MILPITAS FACILITY
STRUCTURAL TEST PRODUCTS
SERVICE TRAINING BULLETIN
2511 / 2514 INDEX

SANTA CLARA FACILITY
SERVICE TRAINING BULLETIN

PRODUCT 2511/2514
BULLETIN NUMBER 1
HEADING PATCH TO WINFLP

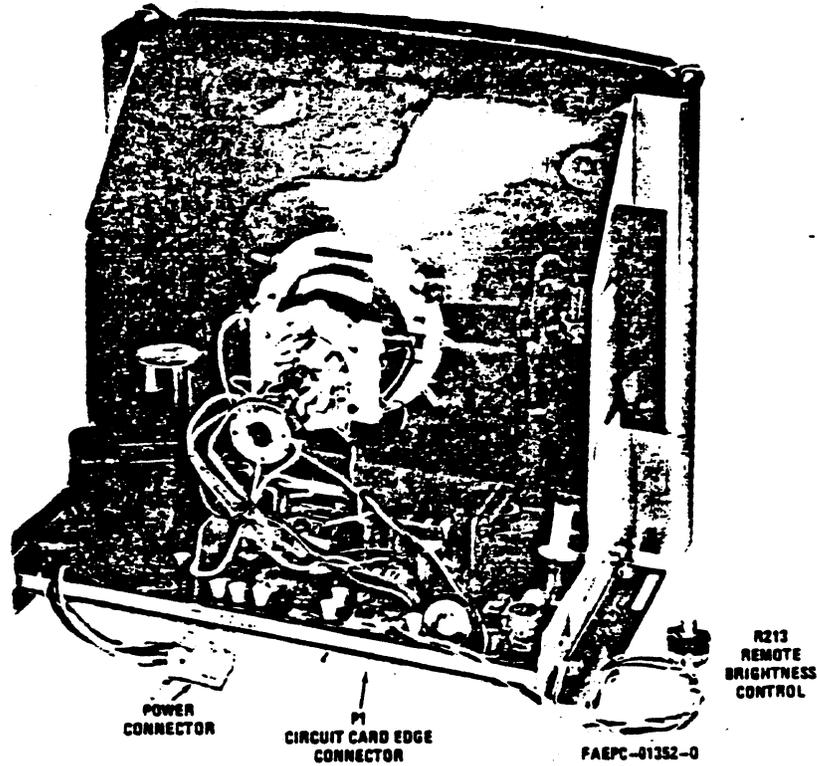
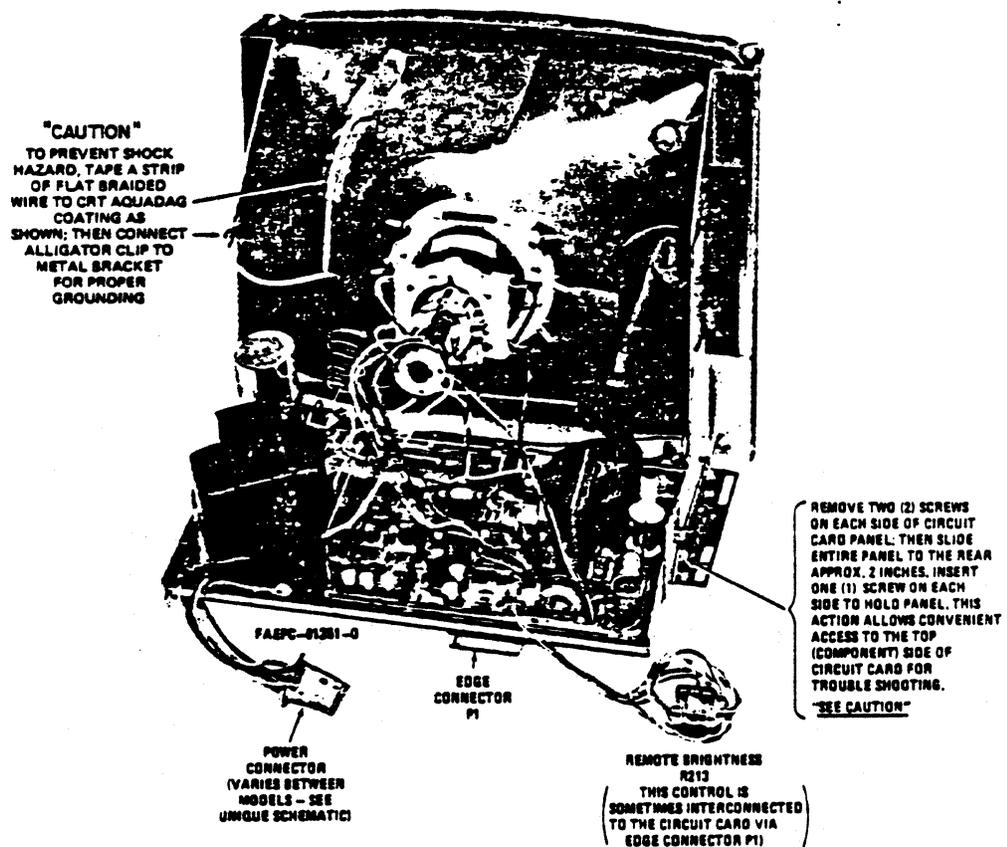
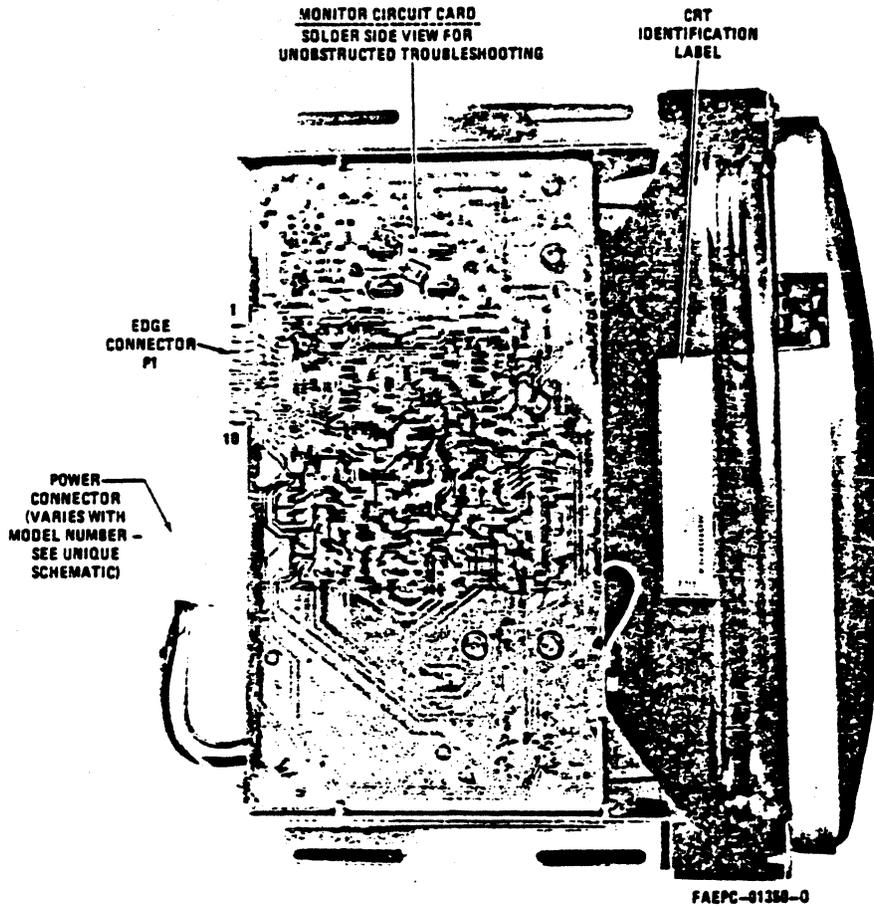
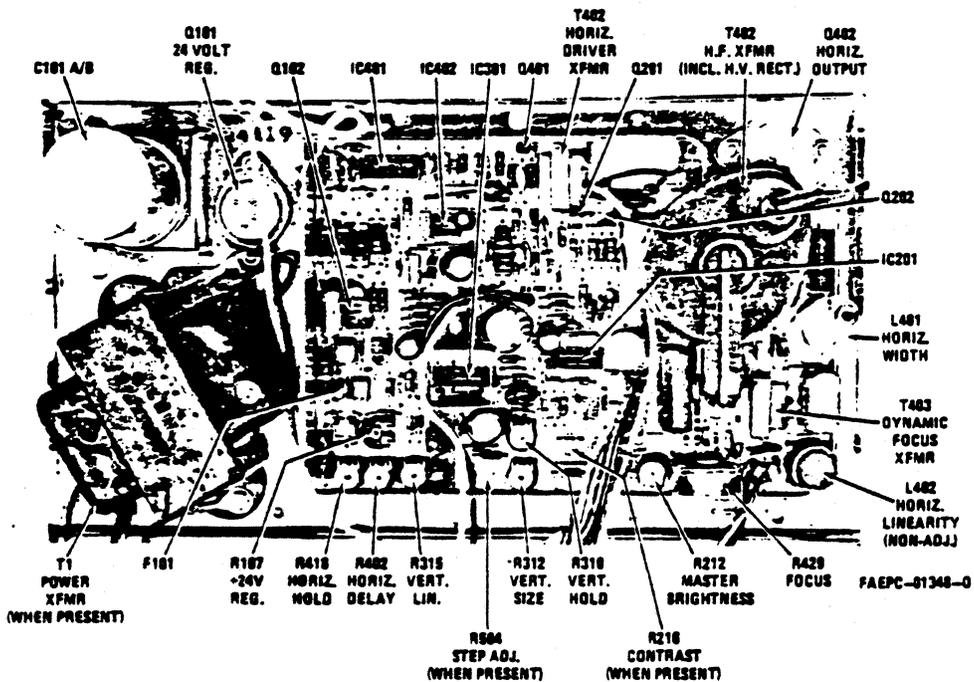
The composite video signal levels are different amplitudes on the 2515 and 2511/2514 CRT outputs. When mixing large screen monitors between these products it may be necessary to adjust the horizontal hold R418.

Attached are two drawings indicating R418 locations.
